EC sound level study (Euro 5)

by TNO-EMISIA-HS-Ricardo

IMMA comments and request for clarification

January 2018

Table 23: Traffic flow rates for road types considered in numbers of vehicles per hour, left for Northern Europe, right for Southern Europe. p. 180 of the EC study report

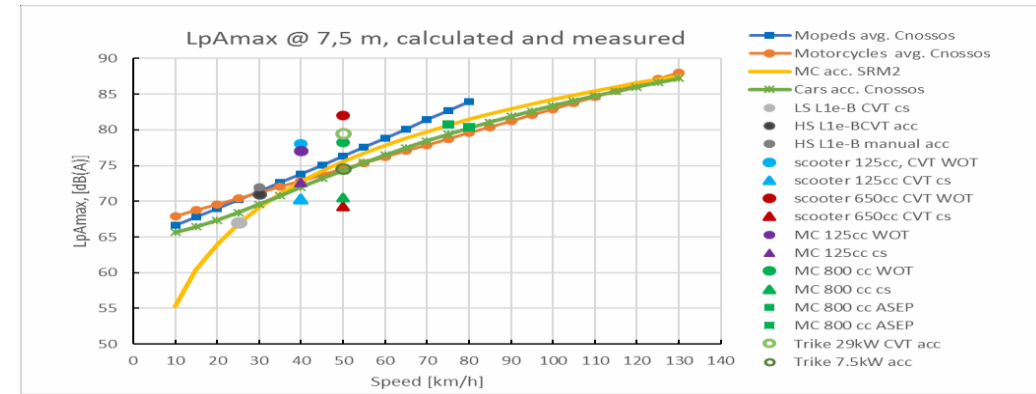
- Traffic flow increases during the night in Southern Europe (for Cars and Medium veh.)?
- Same motorcycle & moped flow in southern Europe for all 3 time frames during the day?
- **If incorrect, this would imply that the calculated L_{DEN} for Southern Europe is incorrect.**
